MEMORANDUM

To: Montgomery Township Zoning Board of Adjustment

Re: **Renard Management, Inc.**
Use Variance, Height Variance, FAR Variance, Major Site Plan
Supplemental Review Memorandum 1
1026 County Road 518
Block 29002, Lots 49 and 50
HC Highway Commercial District

Date: February 15, 2024 supplemental report to November 22, 2023 report

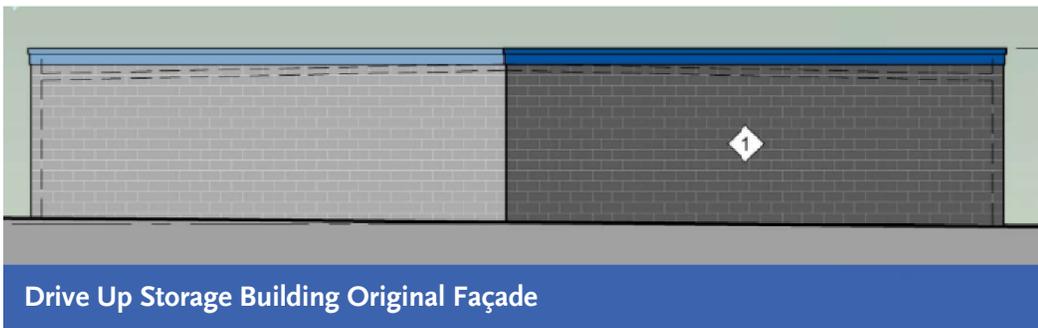
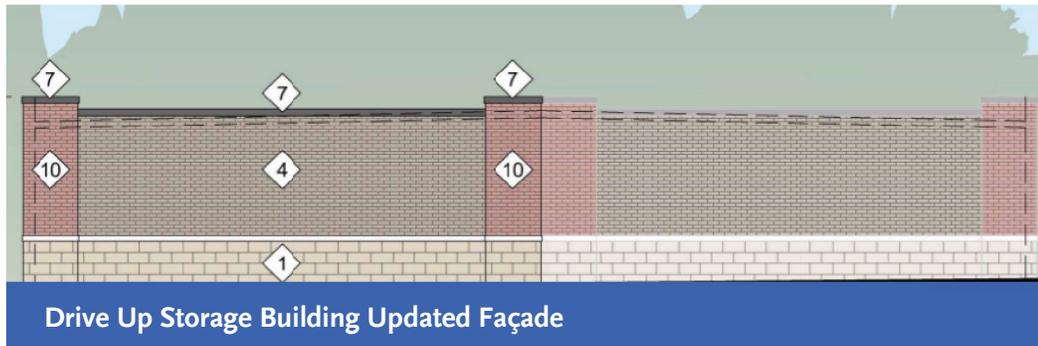
2.1. Primary Building Architectural Plan Changes – Exterior: As recommended in our report dated November 17, 2024, the applicant has made substantial changes to the exterior of the building. Where previously the exterior contained a non-stylized, contemporary design with dark colors and metallic siding, the revised architectural drawings contain a brick façade with additional windows, greater façade articulation, and other more desirable composition of building elements that reads as a faux 20th century industrial structure.

While this design is an improvement over the previous submission, and several recommendations from our previous report were incorporated into the design, this office still recommends changes to the plan.
